Vastern Court, Reading

Statement of Case

Design and Townscape Appendix J

LPA Application Reference: 200328/OUT

Figure 1 Diagram extracted from the Appellant's DAS showing the RSAF parcels (N1-N6) overlaid on the Appellant's block model. The blue line is the RSAF direct alignment and the red line of the Appellant's proposed alignment (DAS Page 63).

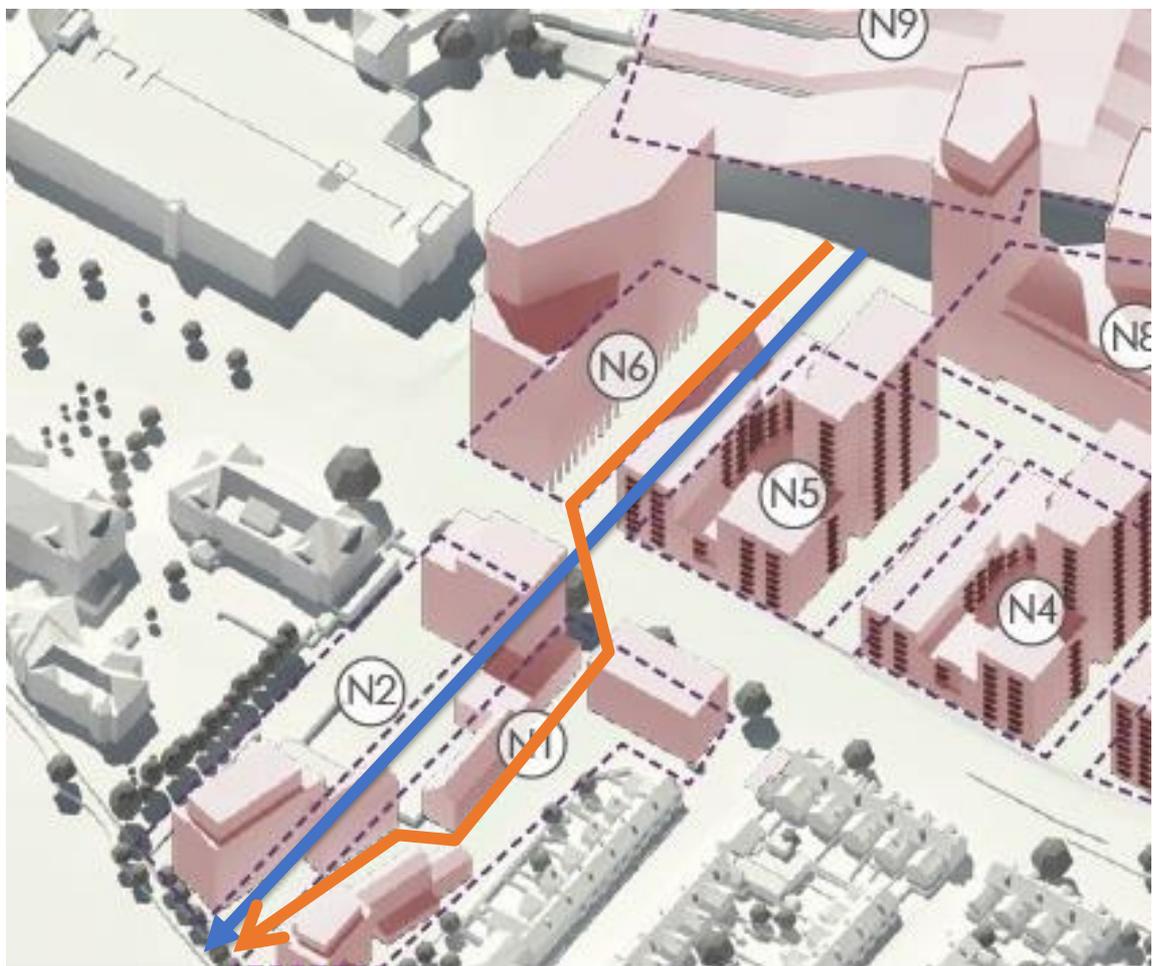
4.7.1 The Application Scheme and corresponding Parameter Plan offers a minimum 23m wide corridor through the site travelling between Plots C and D. The direct alignment and dimensions broadly accord with the RSAF. However, there remains a significant impediment in that the creation of a direct route with a line of sight from the Station to the River route requires coordination between the Appellant and the developer of the adjoining allocated SSE site (CR11g).

4.7.2 The development as proposed fails to demonstrate that a satisfactory direct alignment can be provided in accordance with policy and guidance.
